1250 Maryland Avenue
1250 MARYLAND AVENUE SW
WASHINGTON, DC 20024

SLAB EDGE - LEVEL 09 TO
10

SK#25
7 pages
11 Queries
Date: 07-14-2025

Snap from Arch. drawing 1/A074

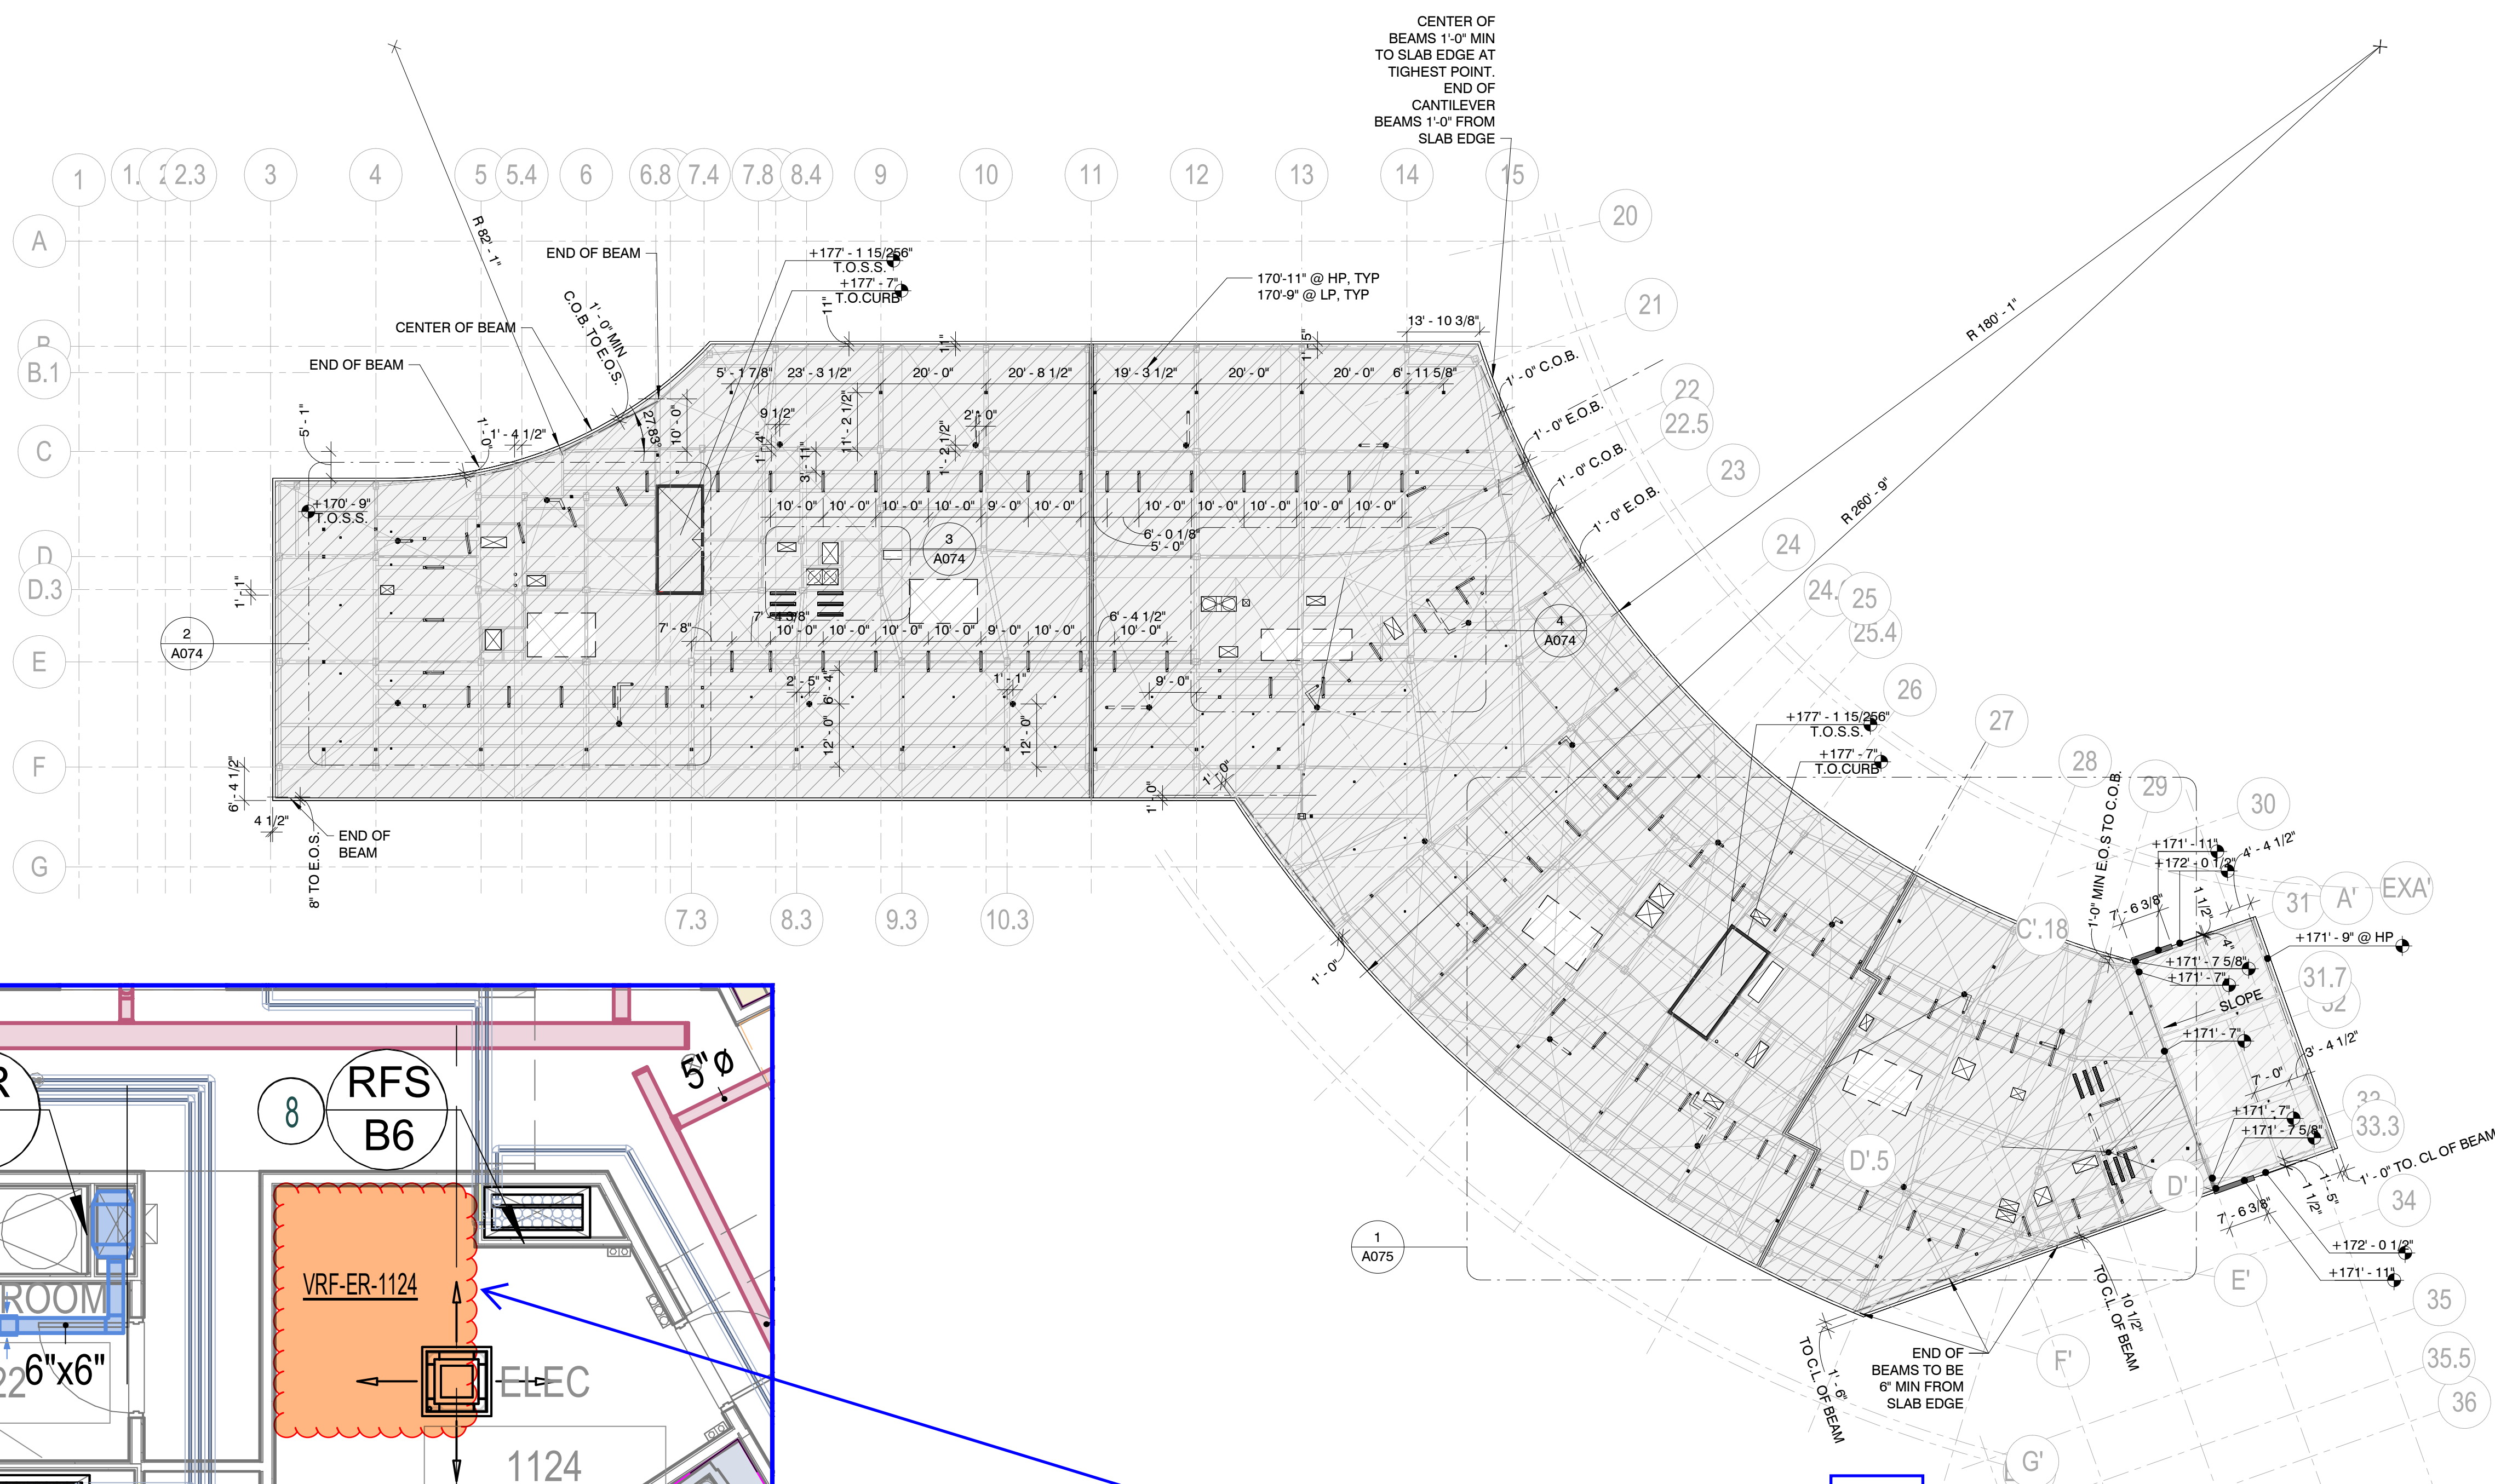
Q12

We assumed the clouded openings will NOT required support frames like angles frames since the opening sizes are small.

Please confirm.

If needed, please review and provide missing dimension for opening size.

Q11

We assumed all green clouded openings will NOT required support frames like angles frames since the opening sizes are small (less than 1-2).

Please confirm.

If needed, please review and provide missing dimension for opening size and location.

**Snap from Mech. drawing M116
LEVEL 11 MECHANICAL PLAN**

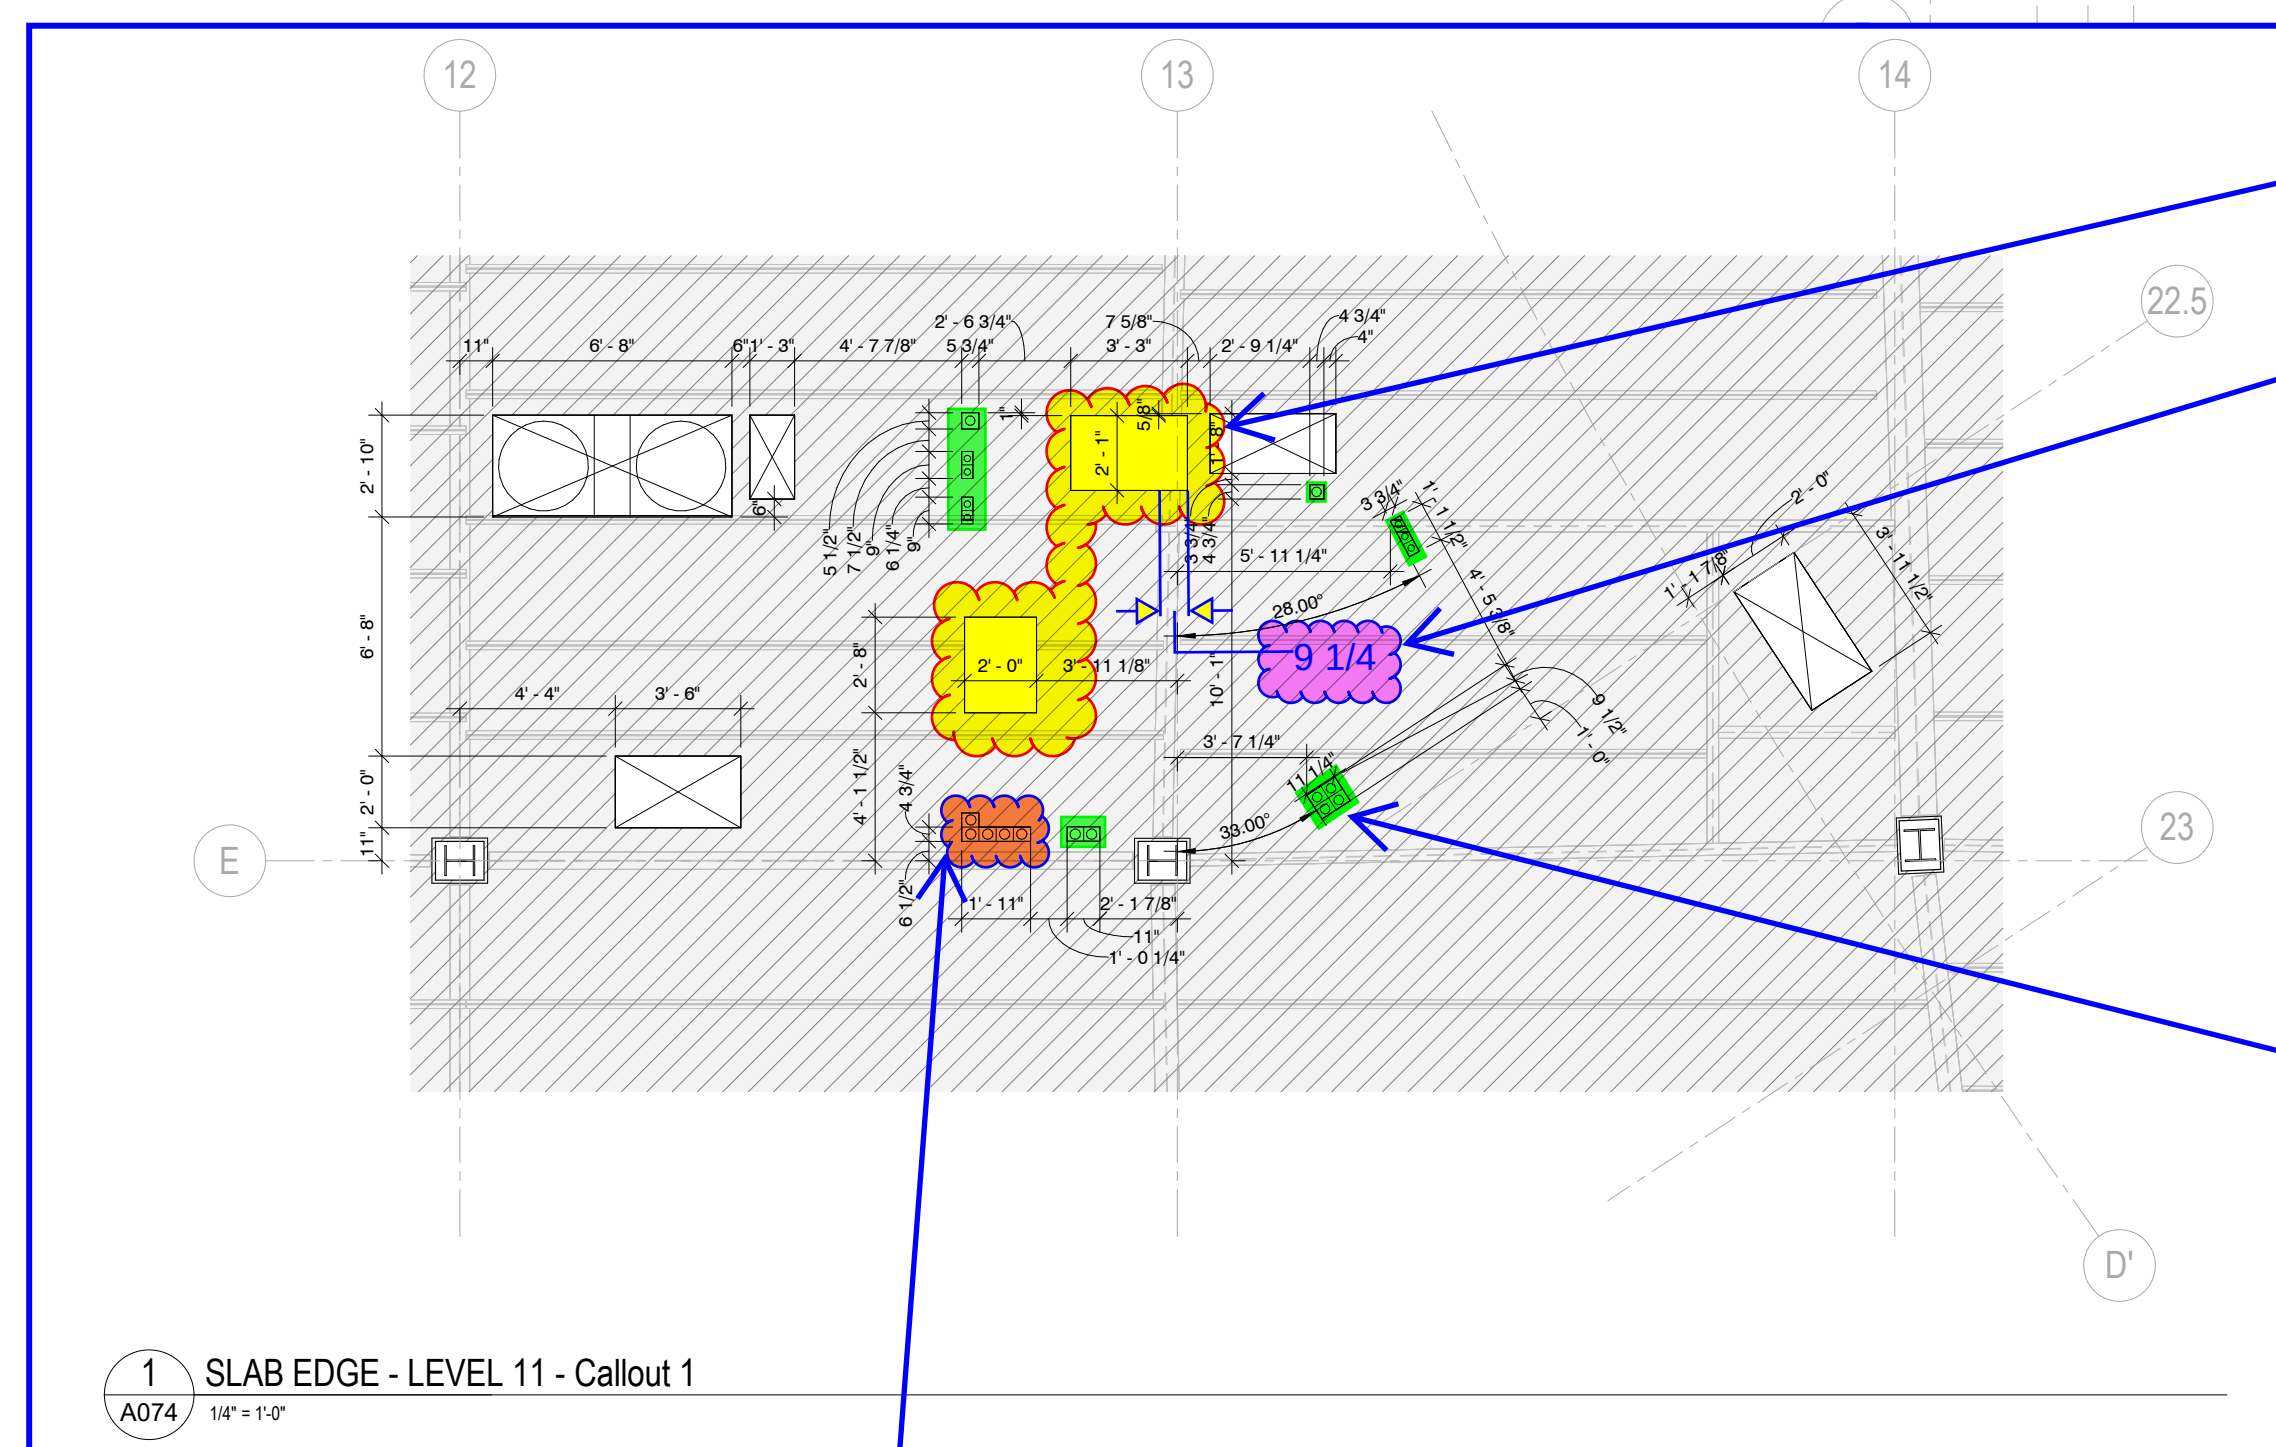
Q10

These yellow clouded openings are not shown in Mechanical drawings. Please review and advise if the opening are necessary?

If yes, the opening extends into the beam location for magenta clouded dimension. Please review and advise.
